ASSESSMENT REPORT

Section 75W Modification Park Fuels Facility, Kooragang Island (07_0066 MOD 5)

Figure 2: Site Figure with approved tank layout

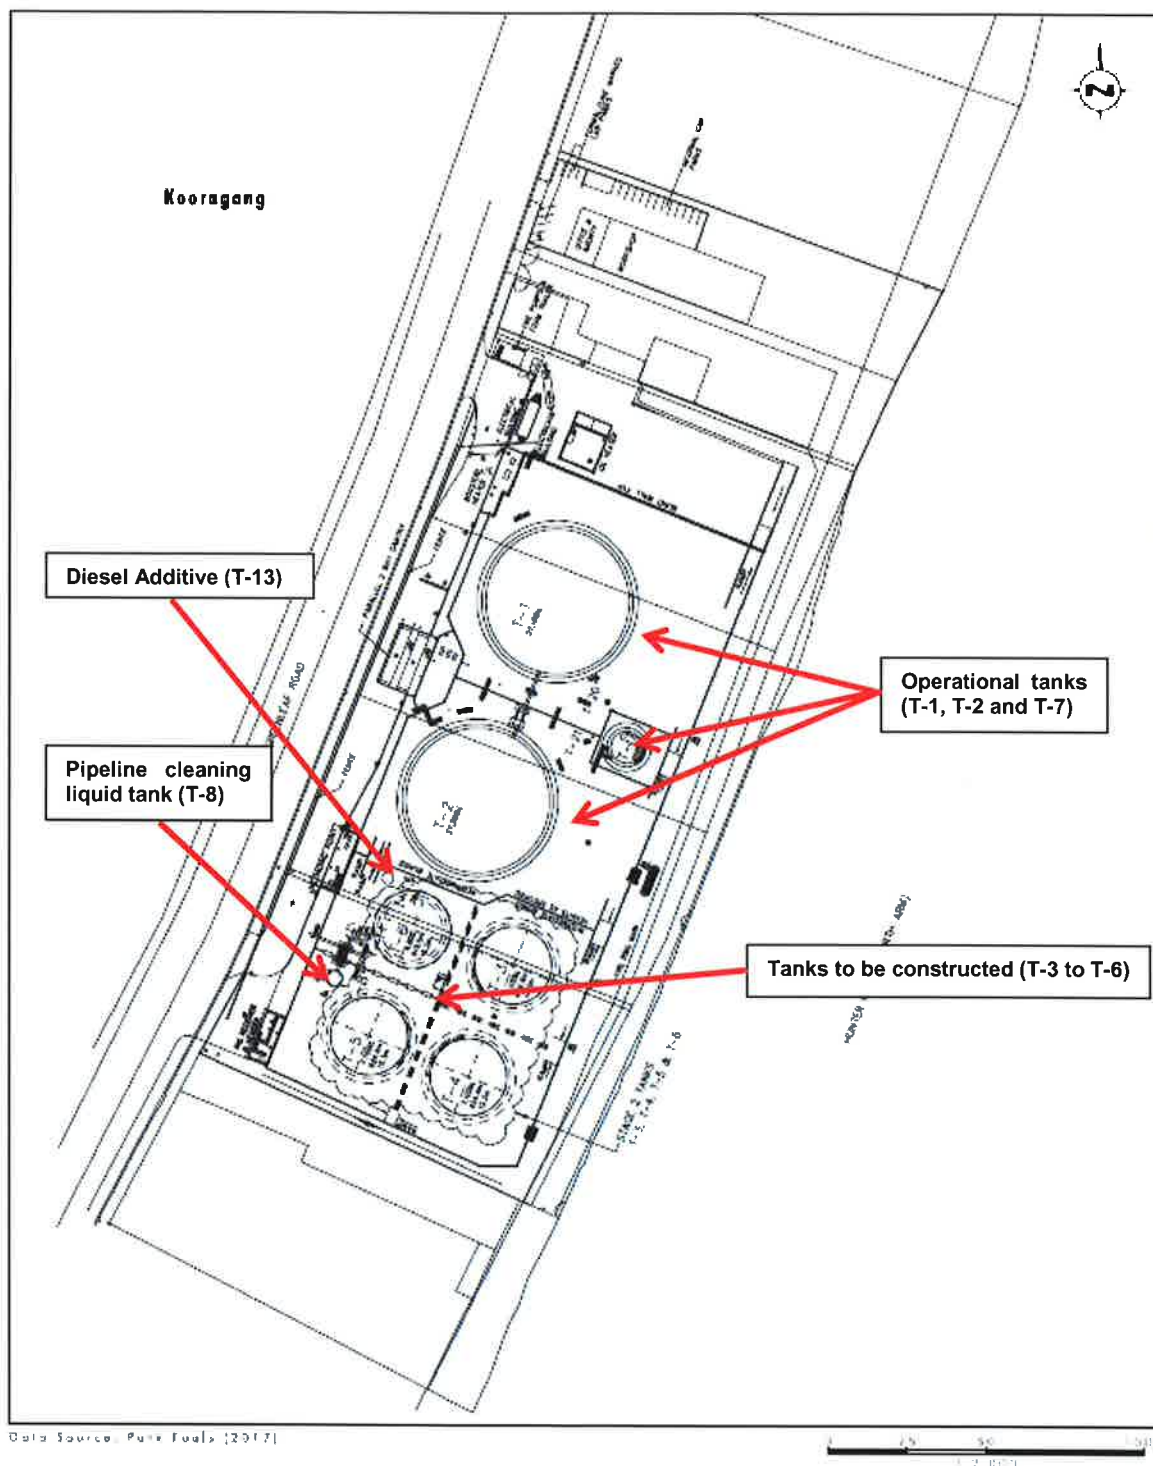
The proposed modification is seeking to allow flexibility in the tank design between fixed and/or internal floating roofs for tanks T-3 to T-6, which are yet to be constructed. Under the original approval, tanks T-3 to T-6 were to be fitted with internal floating roofs to minimise the risks associated with the storage of flammable liquids, however the Proponent intends to only store combustible liquids (diesel, marine fuel oil or biodiesel) in these tanks.

In its submission, the EPA recommended the Proponent provide an assessment against section 63 of the POEO Clean Air Regulation, as the modification request seeks to amend the current approval for internal floating roofs. Section 63 of the POEO Clean Air Regulation outlines the requirements for large storage tanks including the storage of volatile organic liquids, roof designs and where equipment controls are required. Section 59 of the POEO Clean Air Regulation defines volatile organic liquids, as “*any organic compound that exists as a liquid at actual conditions of use or storage, unless it has a true vapour pressure of less than or equal to 25.8mm Hg (0.5 psia)*”.

In response to the RTS, the EPA advised that its comments had been addressed, however recommended that a condition be included to ensure volatile organic liquids are not stored in any fixed roof tanks on-site in accordance with the POEO Clean Air Regulation. Further clarification was sort during the preparation of the conditions on whether updating the existing vapour pressure condition to include tanks T-3 to T-6 would address the EPA's recommended condition. The EPA requested the condition be updated to ensure only combustible liquids with a true vapour pressure of less than or equal to 25.8 mm Hg (0.5 psia) are stored in tanks T-1 to T-7.
